## Stage 1 Road Safety Audit Response Report

Project No: ITM10127  
Project Title: Capitol Park, Leeds  
Title: Stage 1 Road Safety Audit – Response Report (Proposed M62 Junction 28 Improvements: Phase 1)  
Ref: ITM10127-016B TN  
Date: 17 October 2022

<b>Report Title:</b>	Stage 1 Road Safety Audit Response Report – Proposed M62 Junction 28 Improvements: Phase 1
<b>Date:</b>	17 October 2022
<b>Document Reference and Revision:</b>	ITM10127-016B TN
<b>Prepared by:</b>	i-Transport LLP & Pell Frischmann
<b>On behalf of:</b>	Leeds City Council as the Overseeing Organisation

Drawing No. **A13398-T-247** Revision **H**

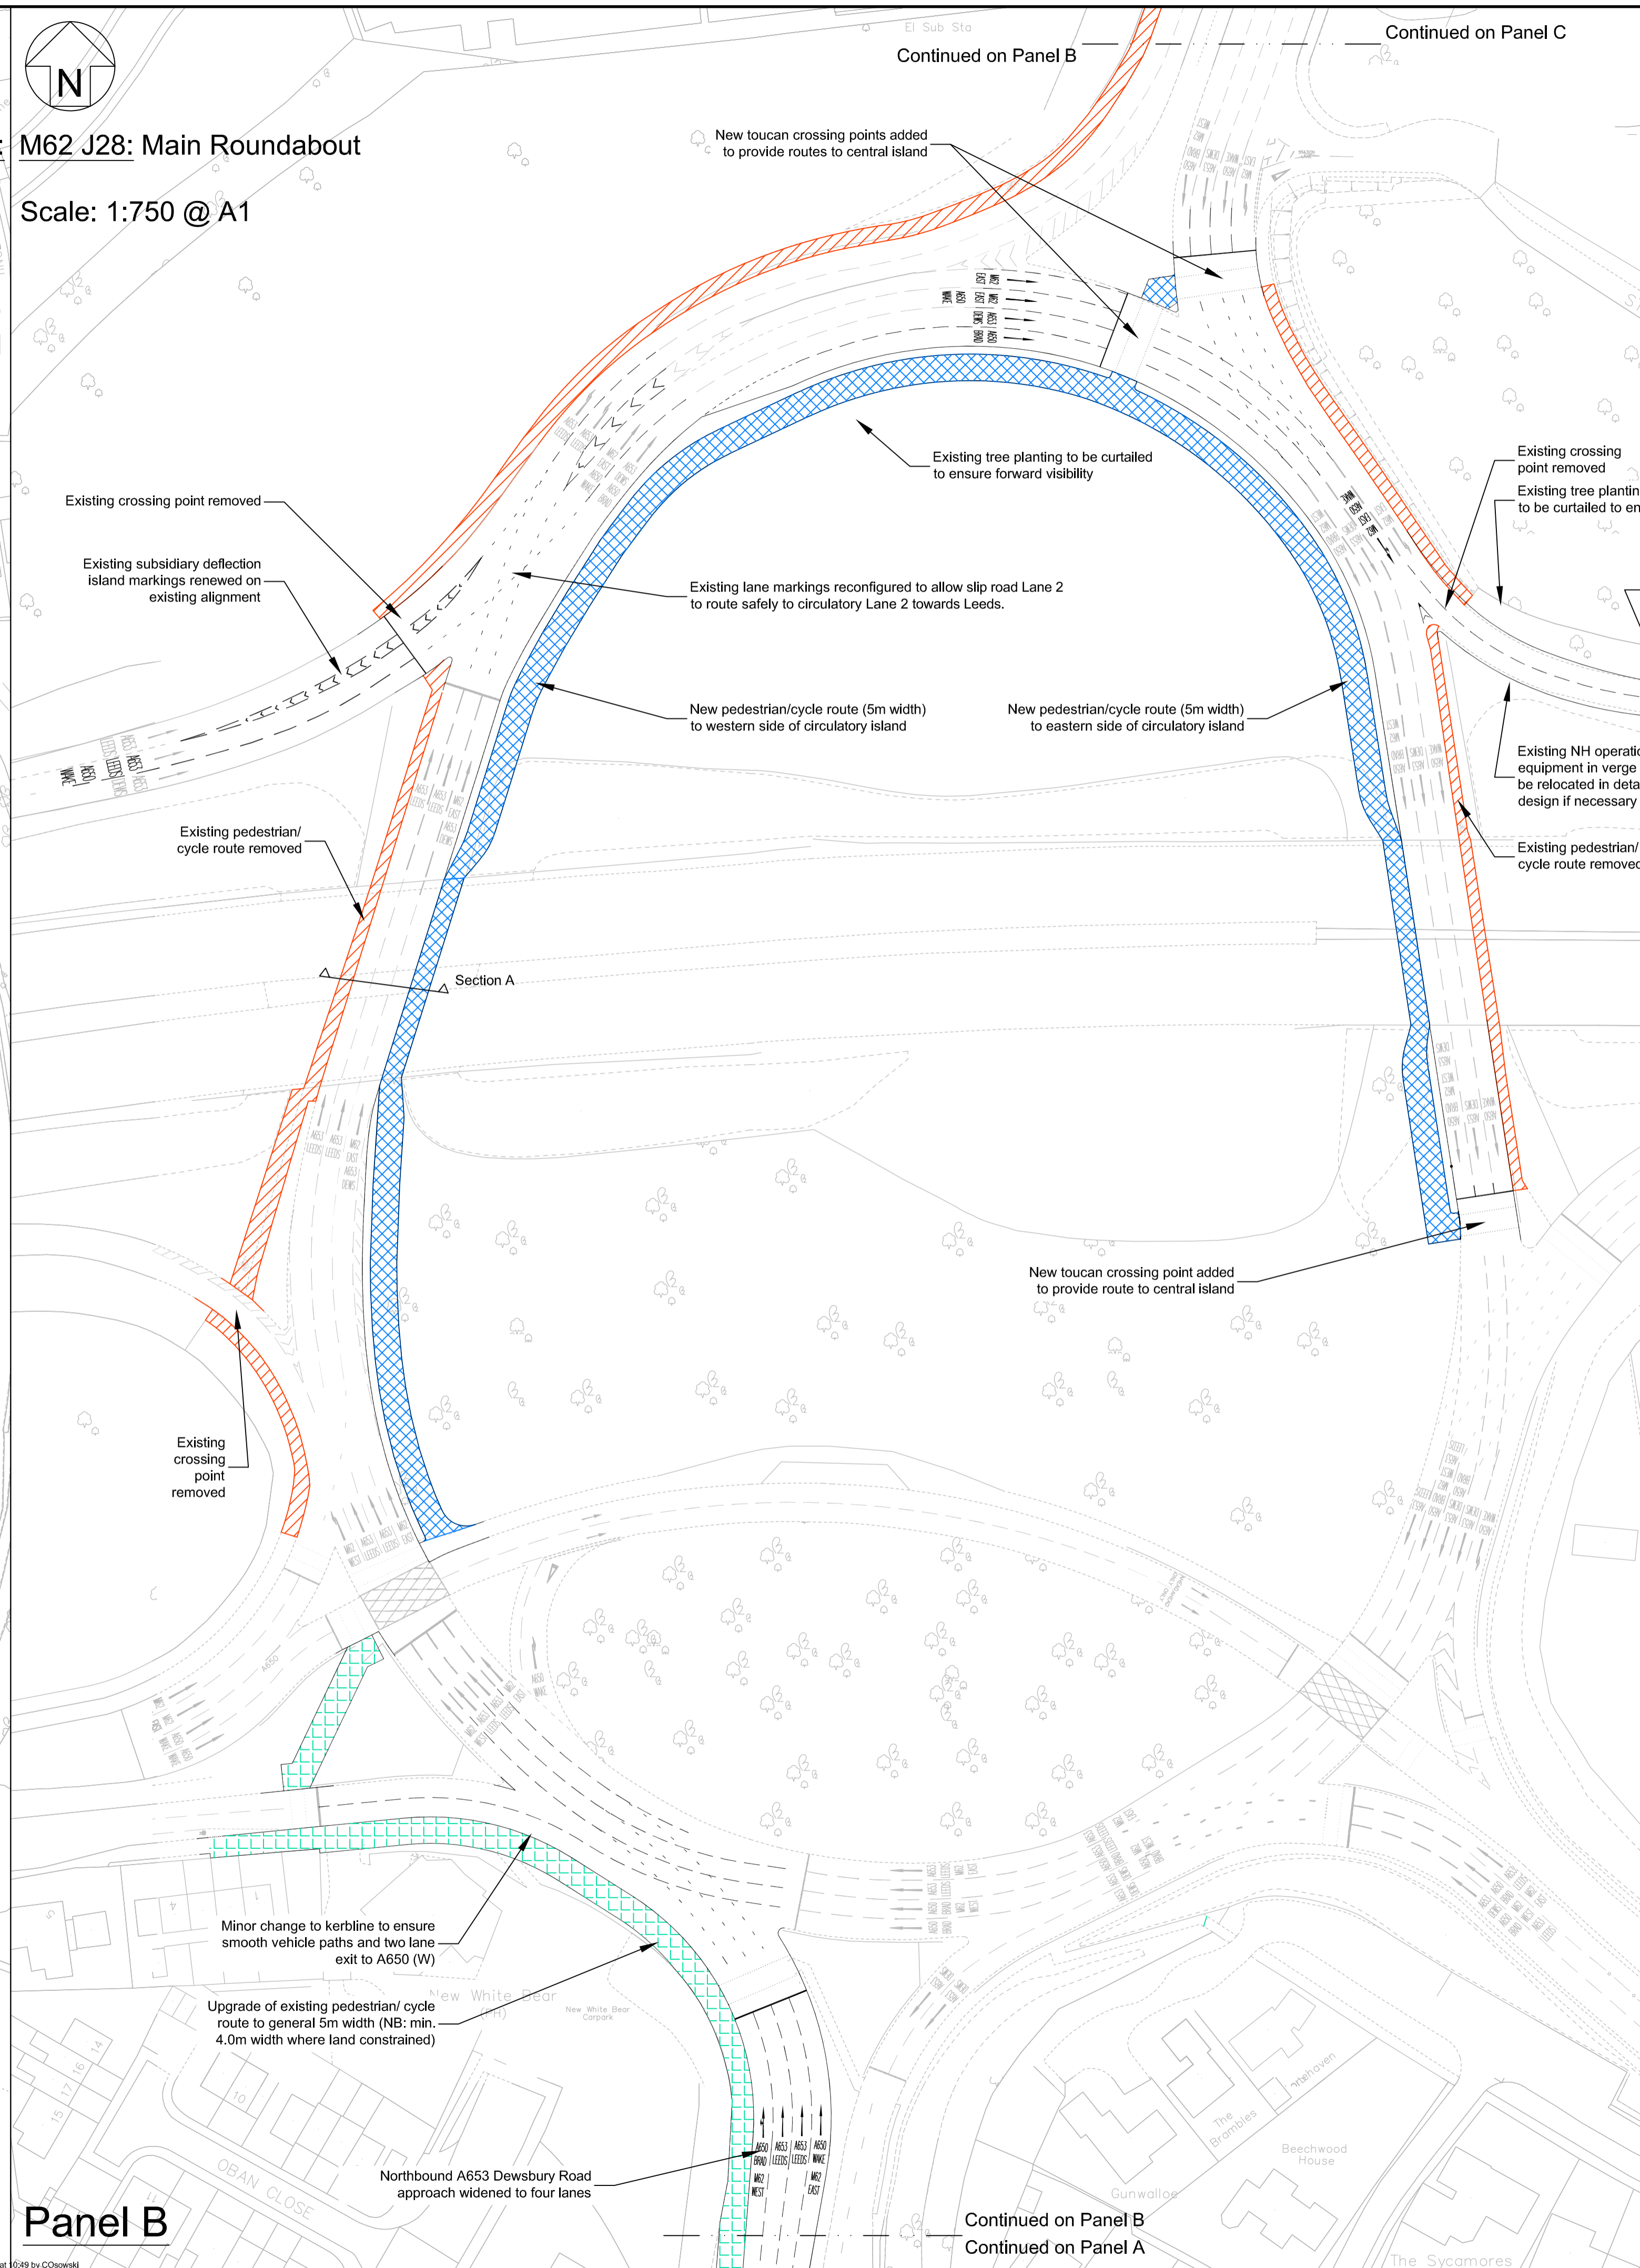
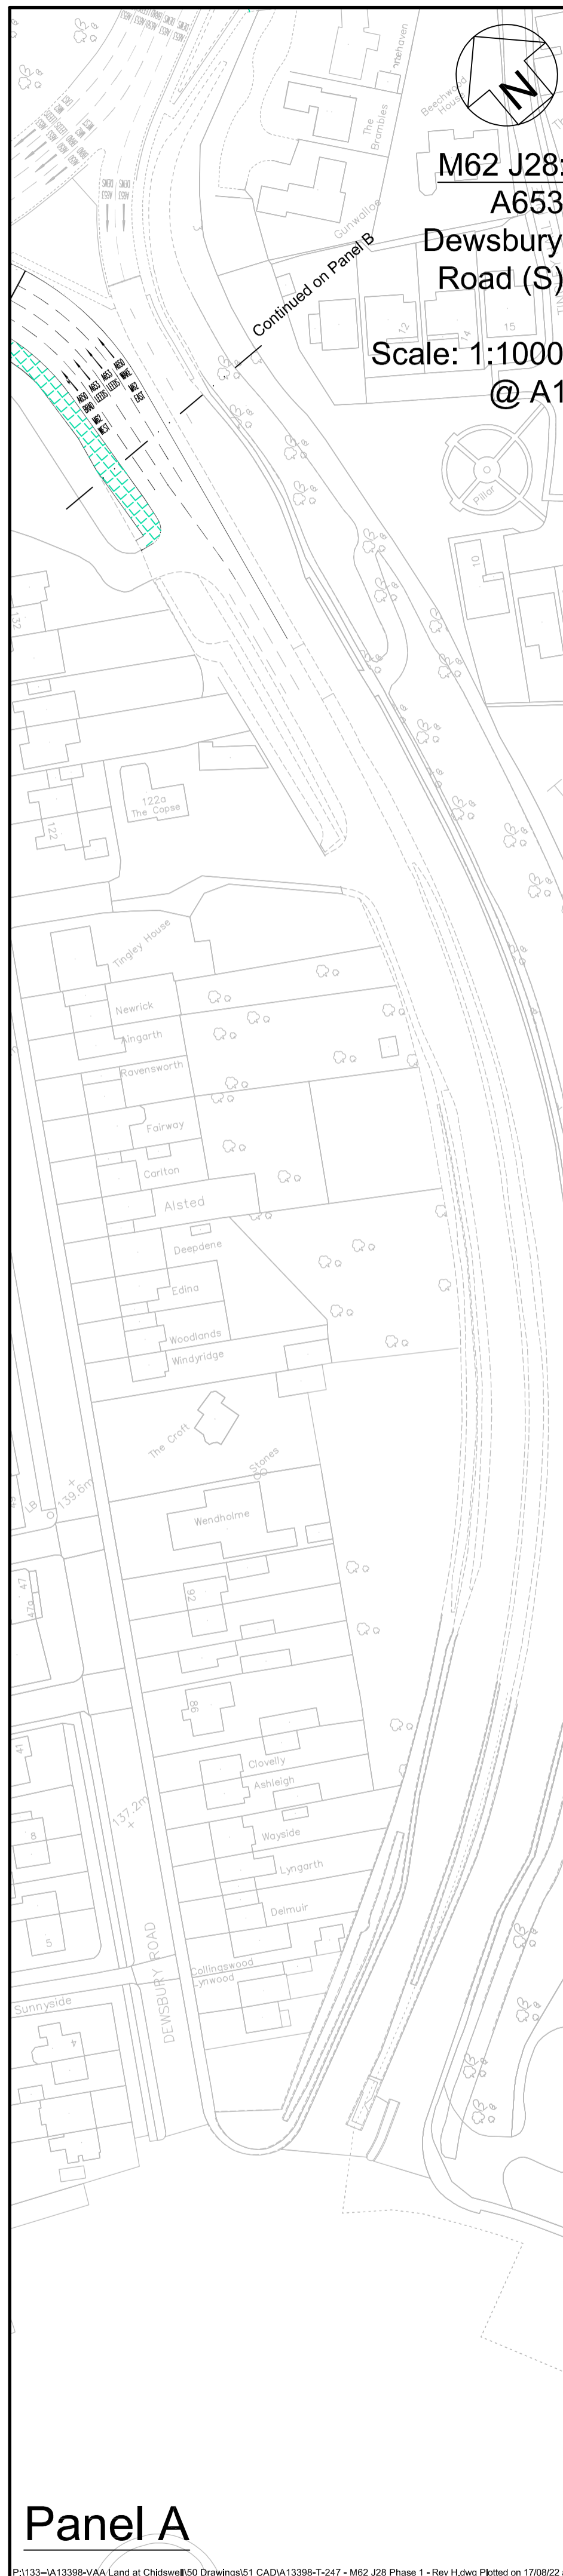
Ref:	RSA Problem	RSA Recommendation	Design Organisation Response	Overseeing Organisation Response	Agreed RSA Action
3.1	<p>Location: The Dewsbury Road northbound approach to the roundabout.</p> <p>Summary: The nearside lane marking could confuse motorists and increase the risk of collisions.</p> <p>The nearside lane worded destinations are correct (A650 and M62), but the arrow shows the lane as left-turn only. Motorists, particularly those unfamiliar with the area and intending to access the M62 west, could be led to believe that they should stay in the nearside lane, then brake and manoeuvre suddenly at the A650 exit to regain the correct lane on the circulatory on their offside. This could increase the risk of tail-end or side-swipe collisions with following motorists in that lane.</p>	<p>It is recommended that the left-turn arrow is replaced with a double-headed straight-ahead and left-turn marking.</p>	<p>The recommendation is accepted. The nearside lane marking has been amended in Revision H of the scheme drawings, enclosed at <b>Appendix A</b>.</p>	<p>The recommendation is accepted.</p>	<p>Nearside land marking amended</p>

REV	DESCRIPTION	DRN	CHK	APP	DATE
H	Update following Stg1 Road Safety Audit	CJO	SME/GJ	PDS/GJ	16.08.2022
G	Updated to actions of meeting 09.06.2022	CJO	SME/GJ	PDS/GJ	14.06.2022
F	-	-	-	-	-
E	Incorporation of Phase 1+ part to Ph 1	CJO	SME	PDS	25.01.2021
D	Extract of Phase 1 from A13398-T-147-D	CJO	SME	PDS	16.12.2021
